L834-T.01.14

**To:** Rete di Assistenza ufficiale Lamborghini  
**Subject:** A Pillar Monocoque Sealing  
**Date:** 07<sup>th</sup>/02/14  
**Pages:** 3

Monocoque A pillar sealing.

All Lamborghini Aventador LP 700 Coupe MY 12 and 13 from VIN **CLA00091** to VIN **DLA01695**

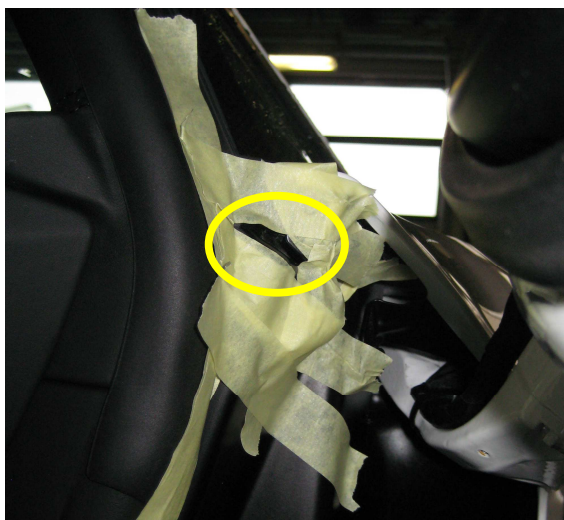
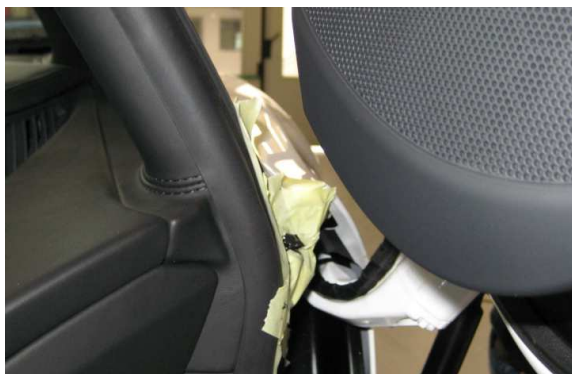
1. Remove the wheel arch undershield: left and right sides (chapter 08 21 – A.).
2. Drain the water from the intermediate hole located in the wheel housing on both sides as shown in picture: holes are symmetrical on the left and right.

(Remark: the picture below shows right sides both sides are symmetrical)

3. Open Both doors.
4. Find the surface to be sealed

5. Apply the paper tape in order to mask the surrounding surfaces of the Area to be sealed.

6. Apply the 3M sealant as shown in the picture, with particularly care to not soil the bodywork.
